Reference: Steamboat Duplex

Garage Window Narrative 200 Sundance Boulevard Steamboat Springs, CO 80487 Permit SPRSF241394-BD1

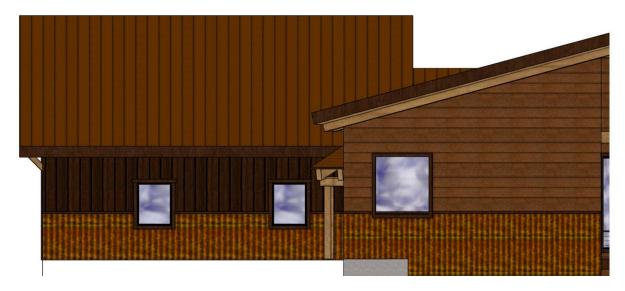
This narrative is in response to the Planning Department Correction 2, which states "CDC 436.H.1.b Side loaded garages shall provide windows or other architectural details that mimic the features of the living portion of the dwelling on the facade of the garage facing the street."

The following image shows the proposed windows being added to the referenced garage elevation (the elevation facing Sundance Court):

There shall be two windows added, spaced equally at third points along the length of the garage wall. The windows shall be 3'-0' wide by 4'-0" tall and shall match the style of the windows on the duplex to satisfy CDC 436.H.1.b.
